City of Lafayette
Lafayette Community Center Restroom Renovation
500 St Mary's Rd.
Lafayette, CA 94549
PROJECT NO. 012-9180

ADDENDUM NO. 2

1 DEMOLITION FLOOR PLAN
1/4" = 1'-0"

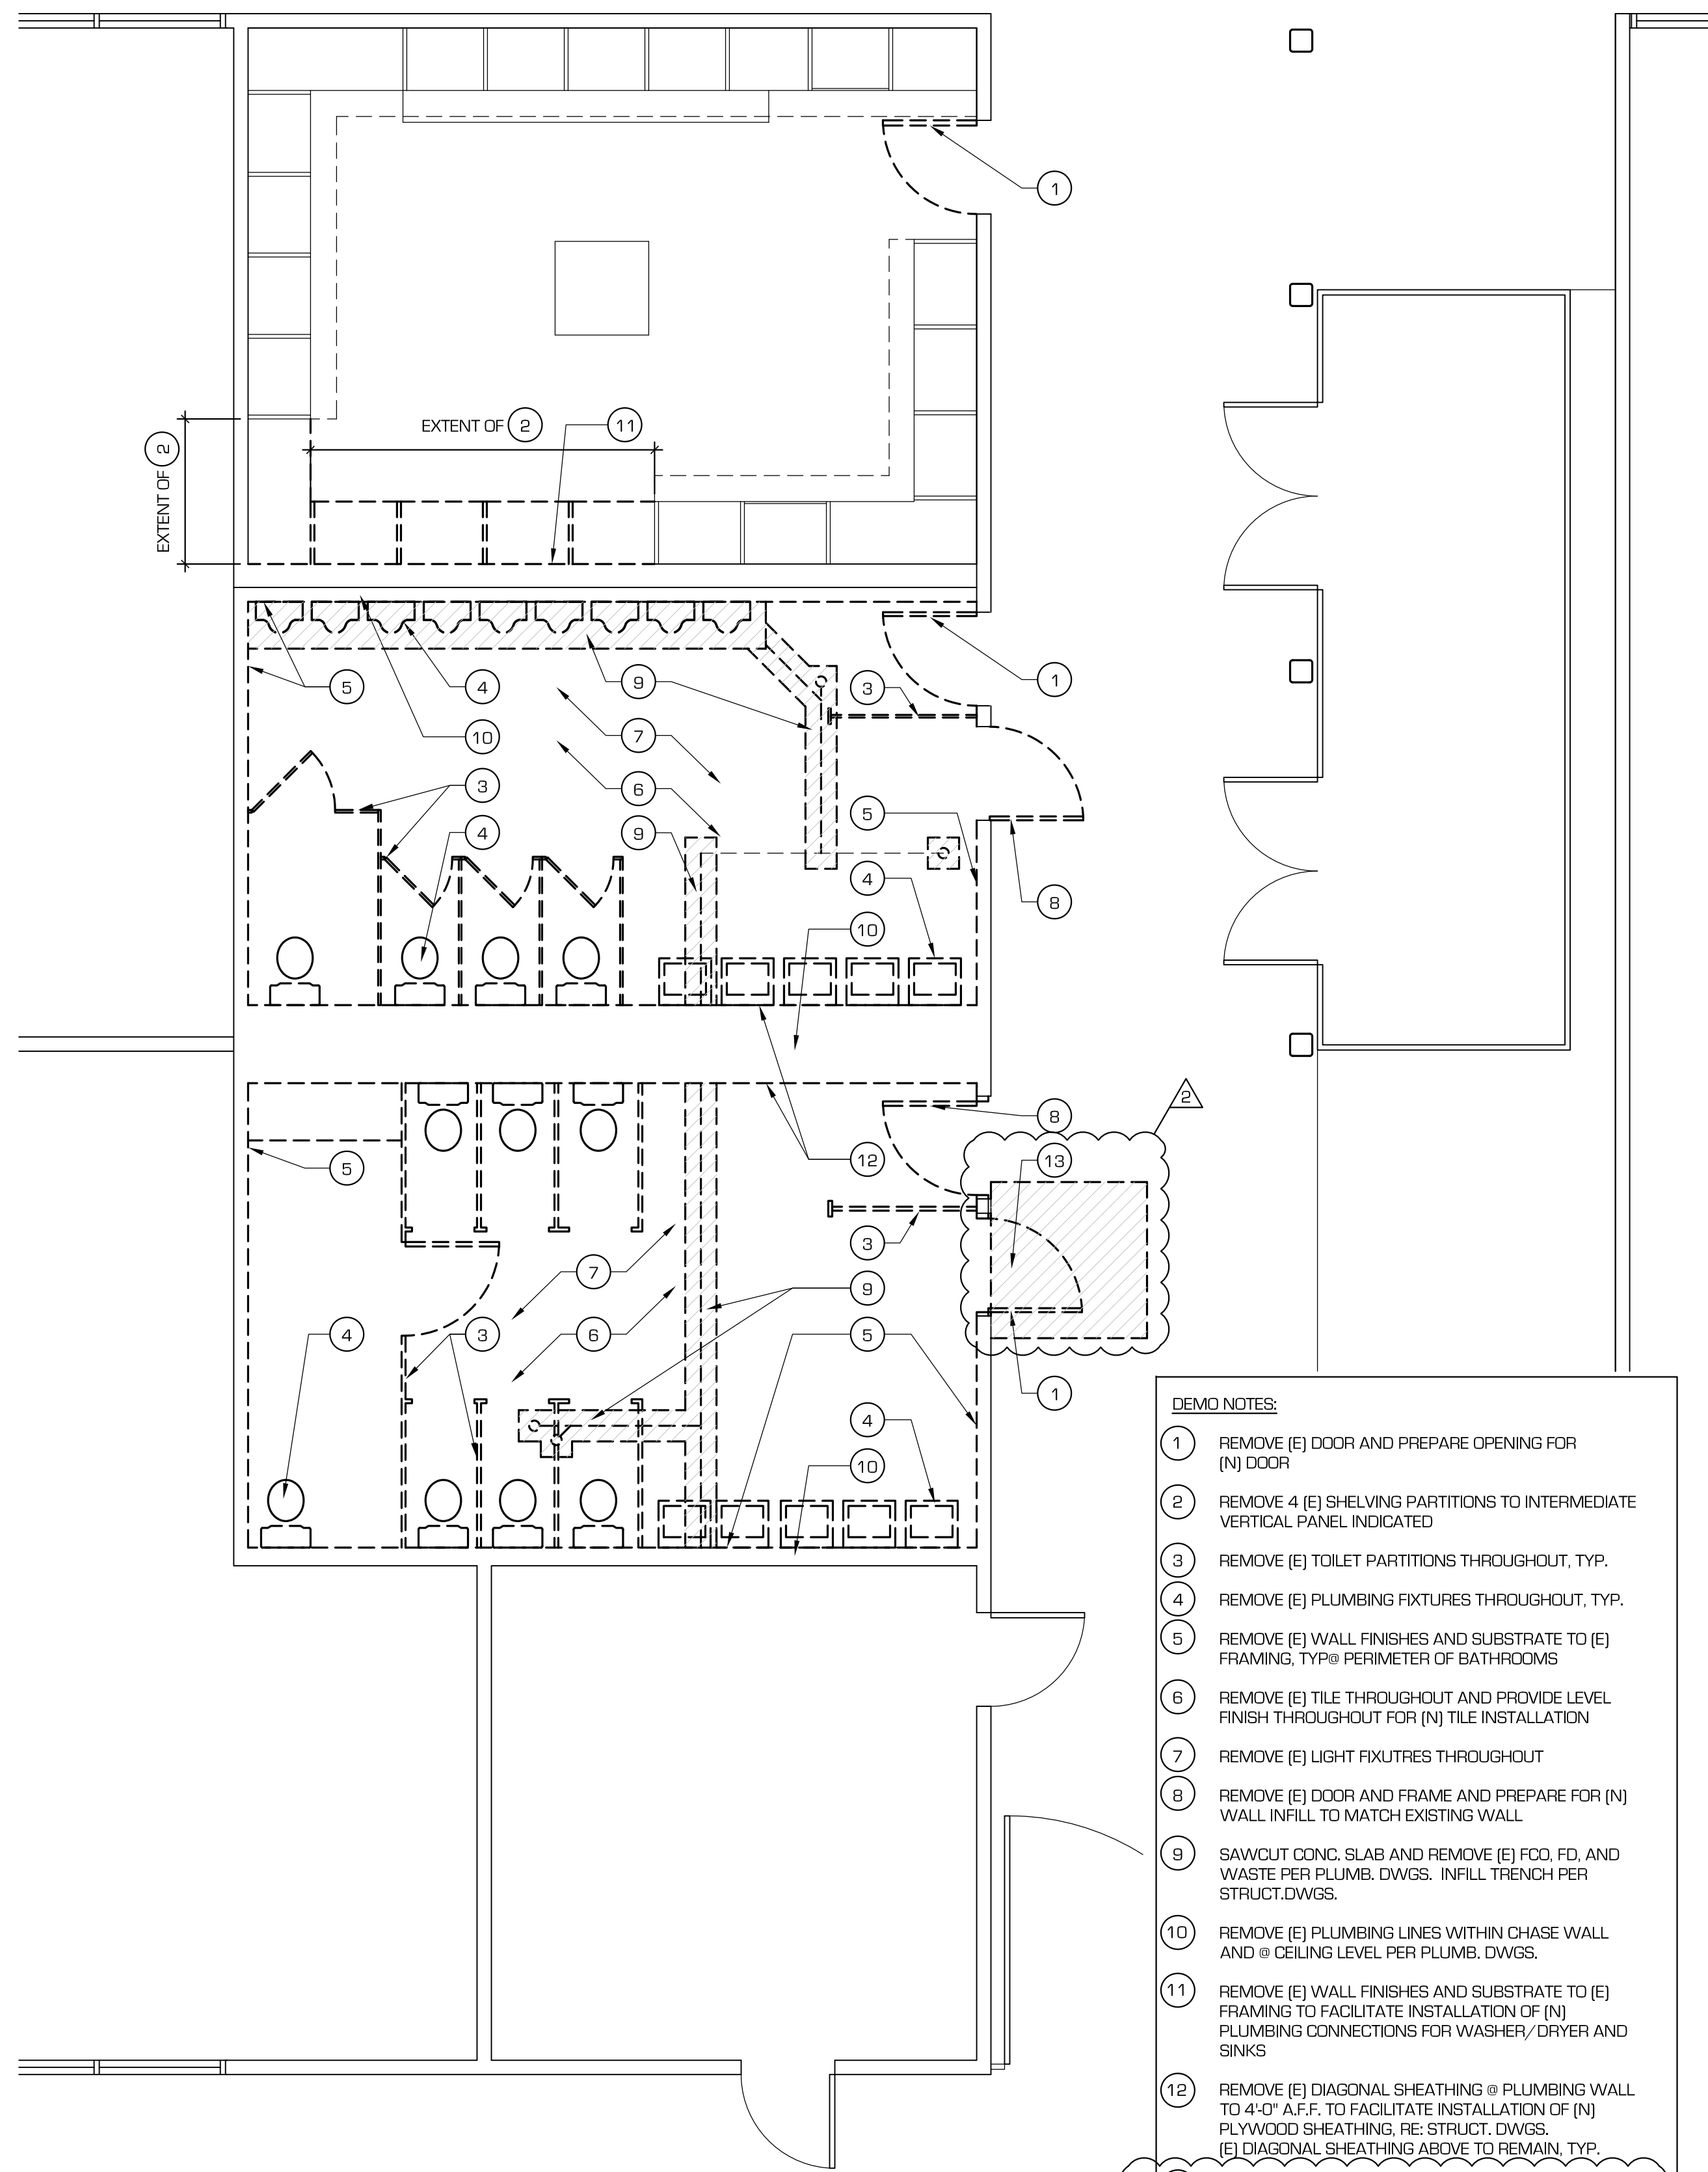
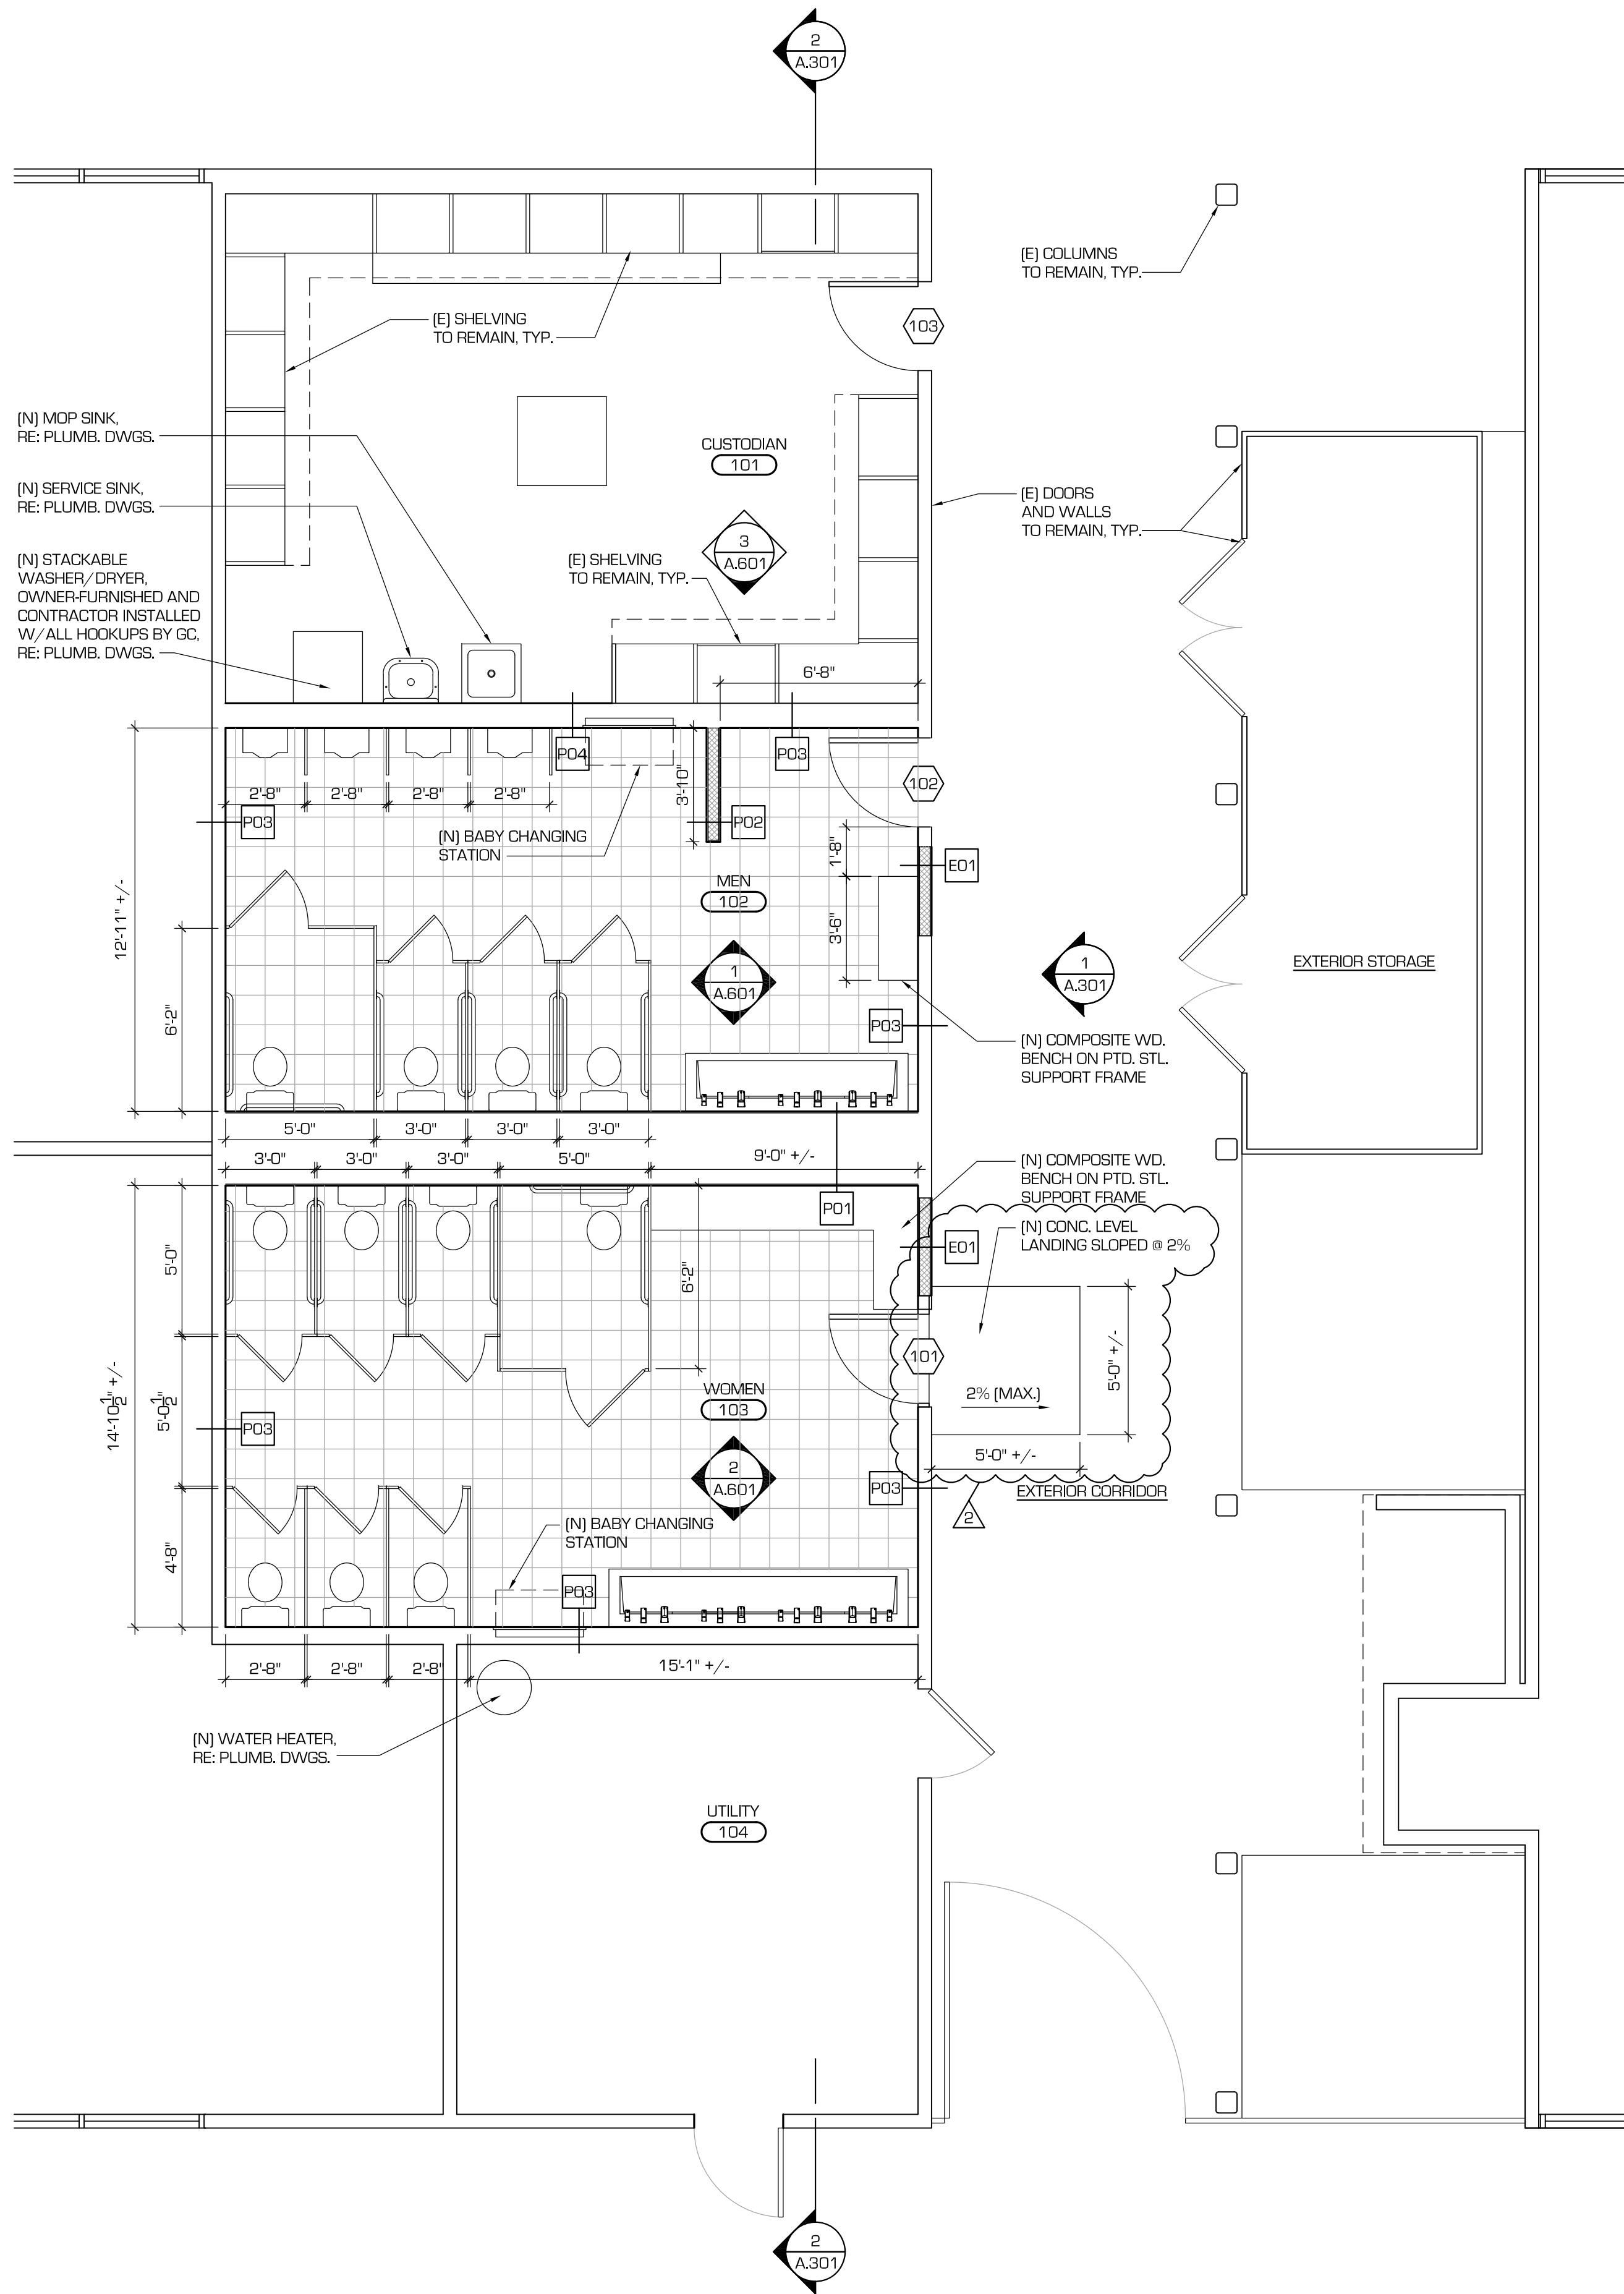
1. Sheet A.201 has been revised with changes clouded. Demolition plan (1/A.201) reflects removal of portion of existing concrete slab to accommodate new concrete apron/landing and Floor Plan reflects new concrete apron/landing @ Door 101.

- 13 REMOVE PORTION OF (E) CONC. SLAB TO ACCOMMODATE (N) CONC. APRON/ LEVEL LANDING. COORDINATE EXTENT OF REMOVAL WITH SLOPES SHOWN ON 2/ A.201. TIE IN (N) CONC. W/ EXISTING PER STRUCT.
